Project	IEEE 802.16 Broadband Wireless Access Working Group < <a href="http://ieee802.org/16">http://ieee802.org/16</a> >	
Title	A Proposal for <a href="#">Construction and transmission of</a> Relay MAC PDU <a href="#">Format</a> in 16j network	
<b>Date Submitted</b>	<b>2007-04-15</b>	
Source(s)	Qu Hongyun, Sean Cai, Mary Chion, Liu Yang, Chen Yuqin ZTE Corporation 712/2, Liantang Pengji Industrial Park, Luohu District, Shenzhen, P.R.China 518004	Voice:+86-755-26773000 exd. 6614  E-mail: <a href="mailto:qu.hongyun@zte.com.cn">qu.hongyun@zte.com.cn</a> , <a href="mailto:scai@zteusa.com">scai@zteusa.com</a>
Re:	IEEE 802.16j-07/007r2:“Call for Technical comments and contributions regarding IEEE Project P802.16j”	
Abstract	This document presents a relay MAC PDU format for IEEE 802.16j.	
Purpose	Propose the sleep mode operations for IEEE 802.16j	
Notice	This document has been prepared to assist IEEE 802.16. It is offered as a basis for discussion and is not binding on the contributing individual(s) or organization(s). The material in this document is subject to change in form and content after further study. The contributor(s) reserve(s) the right to add, amend or withdraw material cont

~~[Insert the following sentence at the end of the section 6.3.3.8.2]~~  
Add new section 6.3.3.8.3 ]  
6.3.3.8.3 Construction and Transmission of Relay MAC PDU using multiple tunnels

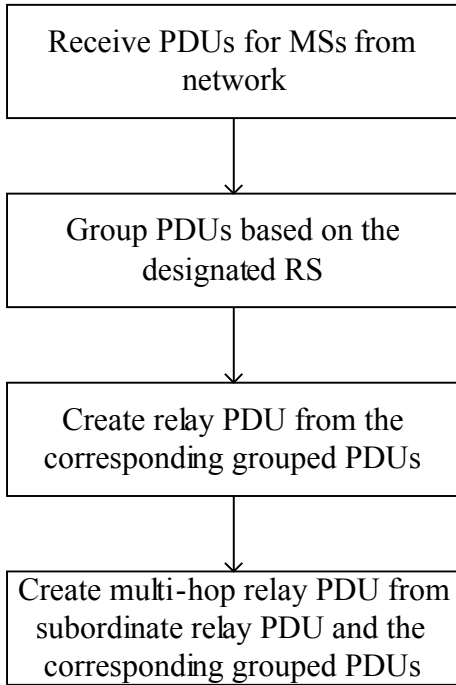
A relay MAC PDU may be constructed by encapsulating multiple 16e MAC PDUs and/or multiple relay MAC PDUs with a relay MAC header. Within the relay MAC header, the tunnel CID (T-CID) shall be included and is used to route the relay MAC PDU through the MR-cell.

MR-BS shall be responsible for creating relay MAC PDU with complete routing information. A Relay MAC PDU may traverse through multiple tunnels before reaching access station. MAC PDUs are relayed depending on the T-CID in the outermost relay MAC header. Once the MAC PDU arrives at the egress of the tunnel, the station at the egress removes the outermost relay MAC header and relays the payload, which may itself contain another relay MAC header. In addition, the station at the egress may calculate and attach CRC at the end of the payload before the payload is relayed.

MR-BS may concatenate multiple MPDU (16e MAC PDU and/or relay MAC PDU) into one relay MAC PDU if the MPDUs are traversing through the same tunnel.
